RE: Filed Office Application for Change
Water Right, File No. 25941

SUMMARY ORDER APPROVING APPLICATION FOR CHANGE AND IMPOSING CONDITIONS

RE: Application for Change in Point of Diversion
Water Right, File No. 25941

GMD3 Change Review

CHANGE IN PLACE OF DIVERSION WATER RIGHT, FILE NO. 25941

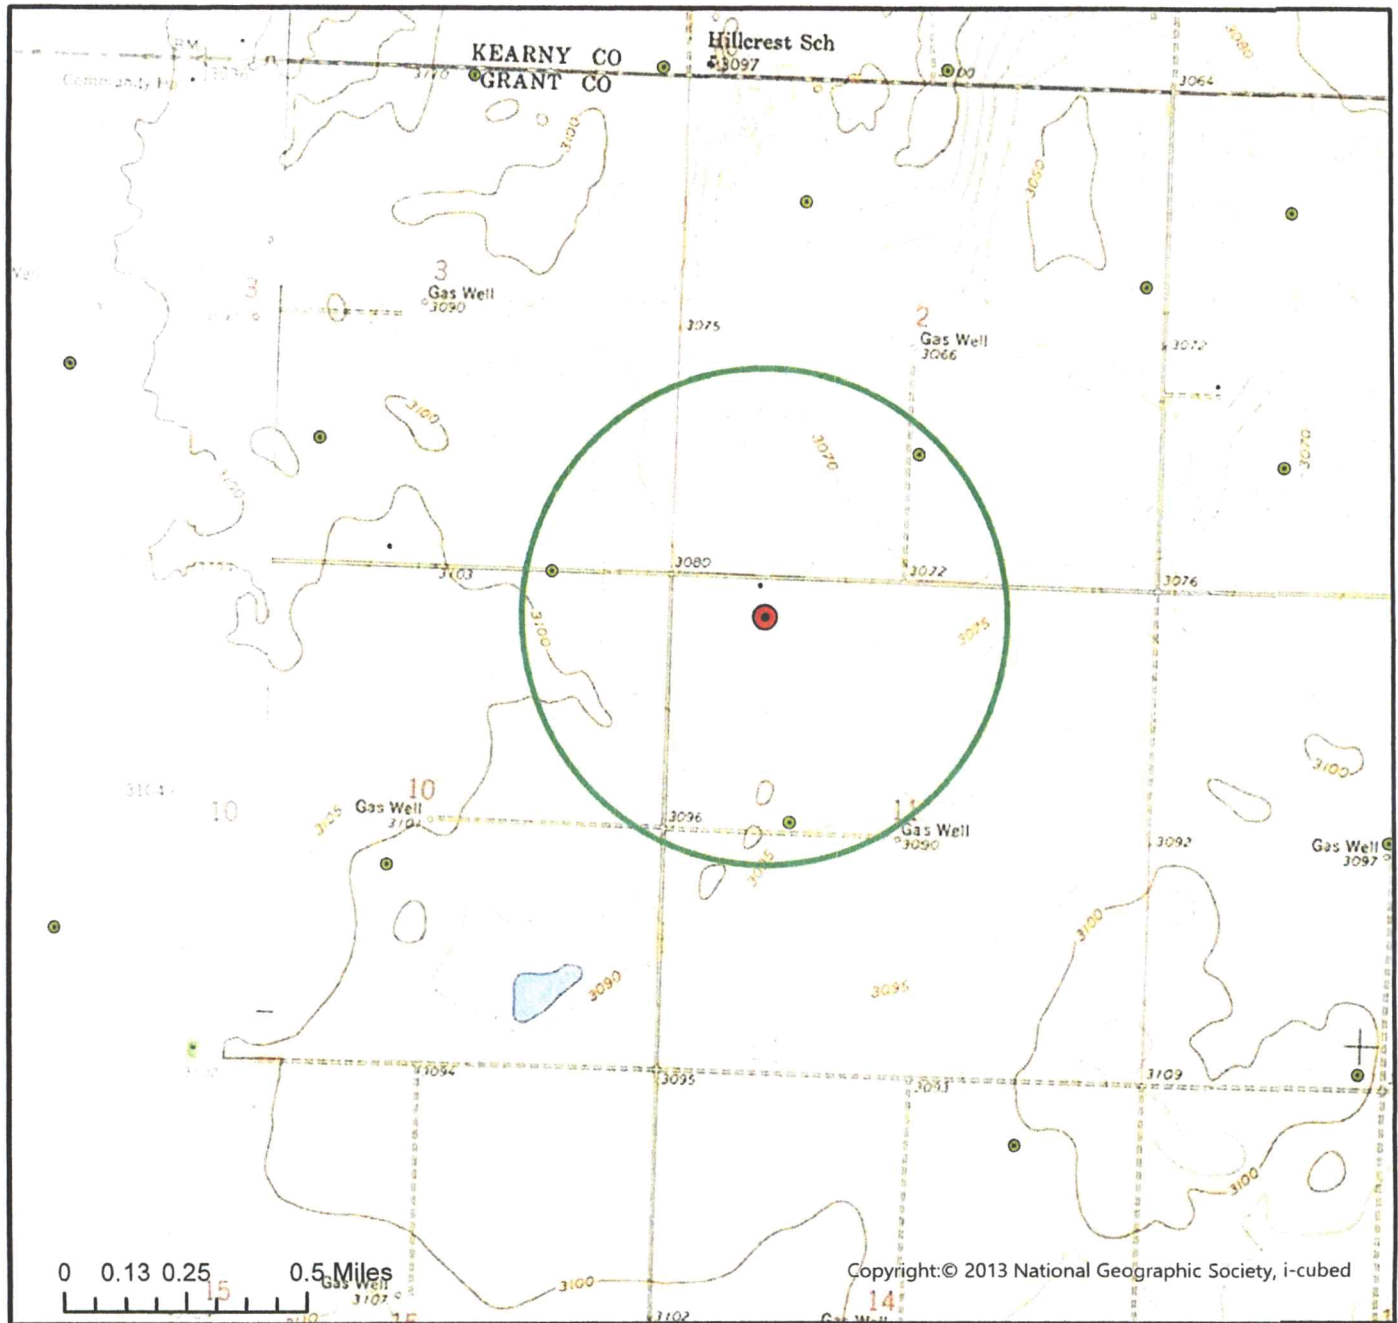
We have completed a review of the application for the above referenced water right. The proposed change in point of diversion is in accordance with current area rules, K.A.R. 5-23-3, as it pertains to minimum spacing to neighboring wells and distance moved.

Every neighboring well within 1 mile of the proposed move was evaluated. Evaluations showed that none of the neighboring wells exceeded the net effect above the maximum allowable threshold and needed no further evaluation. No critical wells were determined in the area. We did not receive any comments from neighboring well owners. Therefore, GMD3 sees this move as meeting current area rules and would recommend approval. If aquifer conditions change or there is a change to the water right in the future, we would be happy to evaluate the effects at that time.

ft. North	ft. West	
Authorized PD	2650	3960	Sect 11-27-36
Proposed PD	4854	4256	
Difference	-2204 n	-296 w	
a2 + b2 = c2	4857616	87616	2223.788 foot move NW

Net drawdown does not exceed the drawdown allowance of 2.5 ft for any well within 1 mile of the proposed location. Therefore, critical well analysis is not necessary.

Recommendation: After review of all available information, it appears current area rules are met. No critical wells determined. Staff therefore recommends approval of the application.
